## Product Change Notification (PCN)

PCN Number	501387	Date Issued	August 19, 2016
Product Family	Please refer to the full part list attachment for details.		
Series	Please refer to the full part list attachment for details.		
Reason for Change	Change to Product		
Change Type Description	This letter is to inform you that changes are being made to the part(s) identified in this Notice. The change will affect the fit, form, function or appearance of the parts. Or, it may result in a change to the specification. The pictures below show an example of the possible differences.		
Reason for Short Notice	Corrective Actions		
Assessment of Change	No change to parts/components FFF		
Internal Molex Qualification Date	September 01, 2016		
Sample Availability Date (Changed Part)	September 01, 2016		
Planned Implementation Date	September 01, 2016		
Method of Identifying Change	Special marking on the product or packaging

Before Change

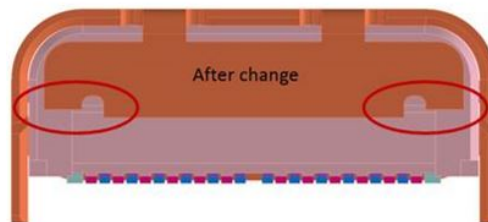
*Move shell carrier link location from center to 2 sides to prevent potential burr caused by carrier link cutting/breakoff process.*
